BRYAN TEXAS UTILITIES

CHANGE ORDER

Contract Name: **Lake Bryan Dam Repairs**

DESCRIPTION: Upstream Slope Sheet Pile **PCM No: 0002**

**PROPOSED CONTRACT MODIFICATION
ATTACHMENT A**

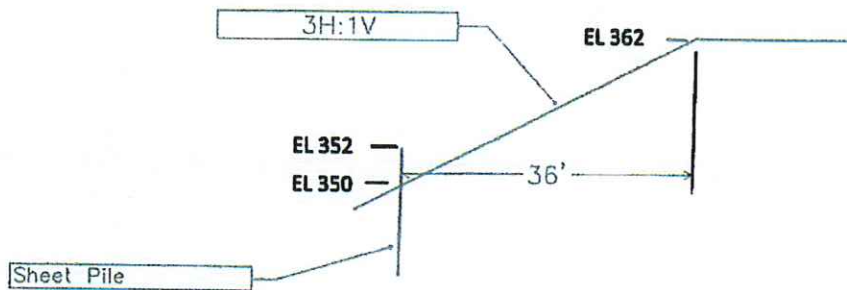
Repair the failed area on the upstream slope of the South embankment toward the left end of the embankment section.

The total length of this area is approximately 200 feet.

Install approximately 20-foot long sheet piles along the length of the failed area. The top of the sheet piles shall be set at approximate elevation 352 feet. Place sheet piles approximately 36 feet from the edge of the crest as shown below.

Place compacted fill to stabilize the crest road.
